Scoping Summary Report

Supplemental Environmental Impact Statement for the Proposed Kendrick Expansion Project Crook County, Wyoming

October 2016

**U.S. Nuclear Regulatory Commission
Rockville, Maryland**

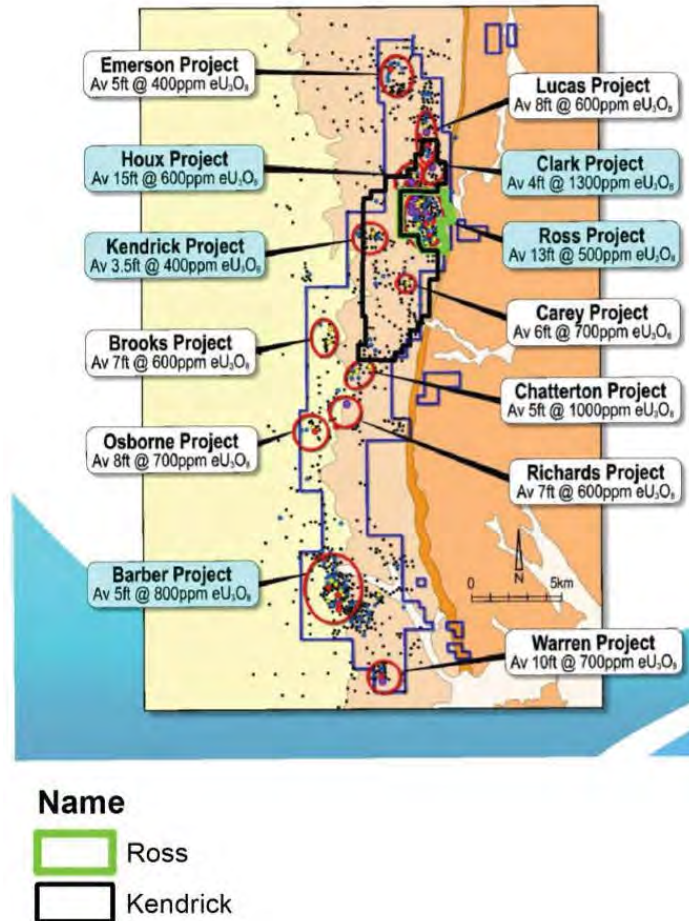
11-6: I. The Scope Of The SEIS Must Include The Entire Ross Project, Which Includes Not Only The Ross Project And Kendrick Expansion, But Also The Further Expansions That Will Inevitably Occur In The Lance District.

As the Organizations explained in challenging the segmented scope of the Ross Project SEIS, the Commission was required by NEPA and implementing regulations to prepare a single, comprehensive EIS that considers the environmental impacts of SEI's plans for ISL mining throughout the Lance District, including not only the initial Ross Project and the Kendrick Expansion, but also Richards and Barber areas. Indeed, it has long been evident from Peninsula Energy public documents and statements that SEI will inevitably be developing *all* of these areas. See, e.g. Figure 1 below.

All of the projects depicted in Figure 1 are reasonably foreseeable and have been proposed by SEI as expansions of its original Ross Project. They are adjacent to each other in geography and connected via a central processing facility. They are also connected via watersheds, aquifer systems, mineral-bearing formations, ingress and egress roads, and any number of areas whose connection directly bears on the full scope of the impacts.

Response: *As the commenter recognized, in LBP-13-10 and a subsequent unpublished order, ASLB declined to admit a contention asserting that the staff's NEPA analysis for Ross should consider the development of the entire Lance District as the Federal action. In CLI-16-13, the Commission declined to grant a review of ASLB's decisions. In its decision, the Commission took notice of the commenter's scoping comments for the Kendrick SEIS that the entire Lance District should be considered in a single EIS. The Commission stated that the staff's SEIS for Ross considered the cumulative impacts of the construction of possible satellite facilities such as Kendrick, including impacts to geology and soils, and surface and ground water impacts. Kendrick SEIS Chapter 5 will address the cumulative impacts of all past, present, and reasonably foreseeable future actions, including Strata's current and future activities within the Lance District.*
